Economic and Social Council

Standardization of technical and safety requirements in inland navigation: European Code for Inland Waterways (CEVNI) (Resolution No. 24, revision 5)

Outcome of the thirty-first meeting of the CEVNI Expert Group and amendments to the European Code for Inland Waterways

Decisions of the thirty-first meeting of the CEVNI Expert Group

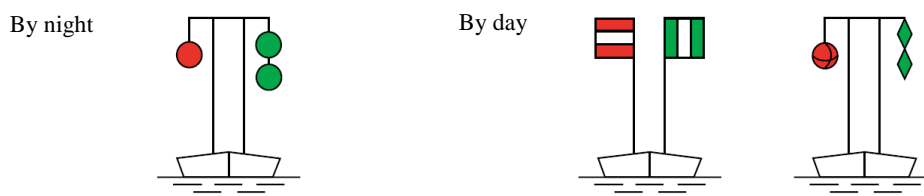
d) when being present or during operations on the deck and the gunwale, if the bulwarks have the height less than 90 cm or the guard rails referred to in paragraph 5, are not installed from one extremity to another.

~~Outboard~~ Overside operations may be conducted only when the vessels are berthed and when the surrounding traffic is not likely to cause any danger.

(a) Section IV BIS, figure 17 ter, *modify*

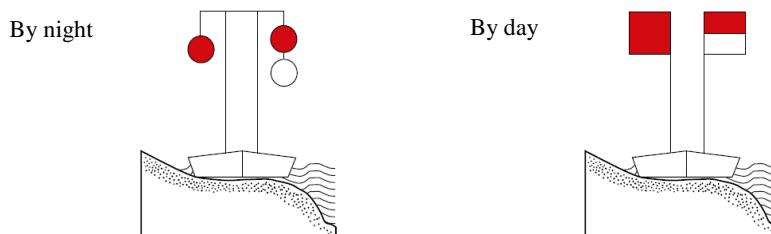
9. The Group discussed the amendment proposals to align Annex 8 of CEVNI with Chapters 3 and 6 of SIGNI (CEVNI EG/2019/16) and decided to introduce the following modifications in Annex 8:
